# Sunbury South and Lancefield Road ICP, Infrastructure Costings Expert Witness Report

## Expert Witness Report

Hi-Quality Quarry Products Pty Ltd

18/10/2020

**Figure 3- LR-BR-01 Concept Design**

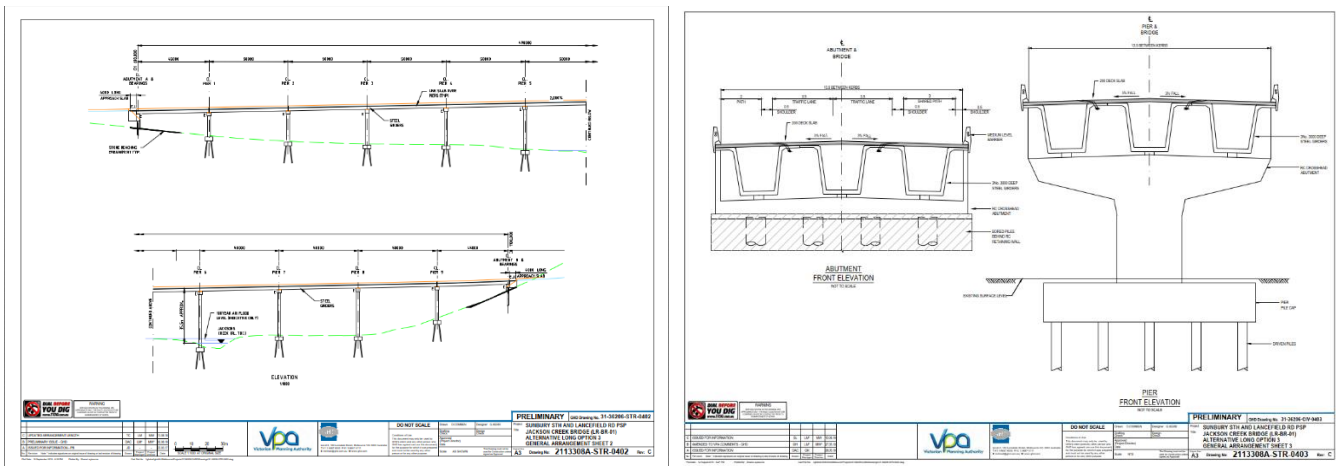
The construction form is detailed as 3000 mm deep steel girders, on Reinforced Concrete cross heads supported by driven piles, the general arrangement drawings suggest 3 No steel girders will be sufficient for the cross section with individual spans of up to 50m.

The use of steel girders allows for spans greater than those that can be accomplished with super T concrete beams and hence reduces the quantum of work required to take place in the creek, overall span is approximately 490 m and requires nine piers and two abutments over the full span.

In the decision to go with the steel girder option it appears that the VPA have selected a more expensive option based on the reduction to effects on the waterway and cultural heritage. My opinion is that with a long bridge/wide waterway that these issues could be overcome and that a super-T multi-span option of circa 35m per span would be more cost effective this needs to be considered against the constructability issues and those of any sensitive overlays.

Other options to optimise the design/ cost of LR-BR-01, on observation I believe that the vertical alignment can be lowered by approximately 500mm over the length of the bridge. This will reduce the overall footprint of the structure, the bulk earthwork quantities and overall span of the structure and could lead to a reduction of overall cost.

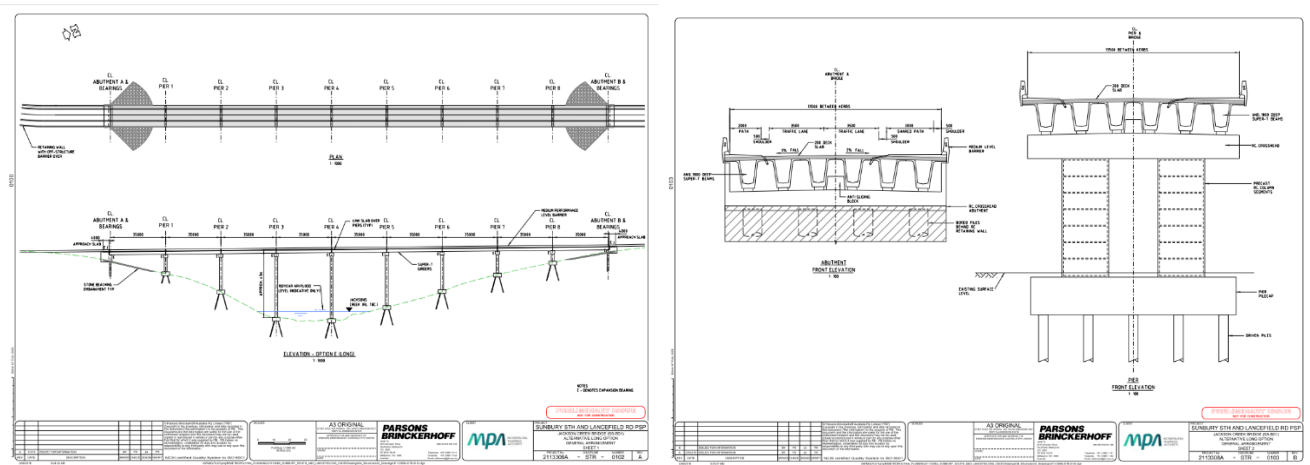
The construction form is detailed as 1800 mm deep super T concrete girders, on reinforced concrete cross heads supported by driven piles, the general arrangement drawings suggest 6 Super T girders will be sufficient for the cross section with individual spans of up to 35m which is in keeping with current design practise. The structure form accommodates a pre-cast option for the piers and cross heads which is in keeping with current construction approaches.

The decision to adopt the Super T beam option is most likely to be driven around overall materials cost, the structure SS-BR-01 however has a height above ground in the order of 43 m, and overall cost may, from a constructability point of view, be affected by this, the large span will be reflected in the corresponding installation requirements and can amount to a considerable cost. It may be worth considering a change to steel girders for this structure. Which probably needs a constructability workshop.

Other options to optimise the design/ cost of SS-BR-01, on observation I believe that a vertical alignment can be lowered by approximately 500mm over the length of the bridge. This will reduce the overall footprint of the structure, the bulk earthwork quantities and overall span of the structure and could lead to a reduction of overall cost by up to 5 to 8 %. Also, the horizontal alignment of SS-BR-01 suggests that an amendment could be achievable with a corresponding reduction in overall span of the structure.
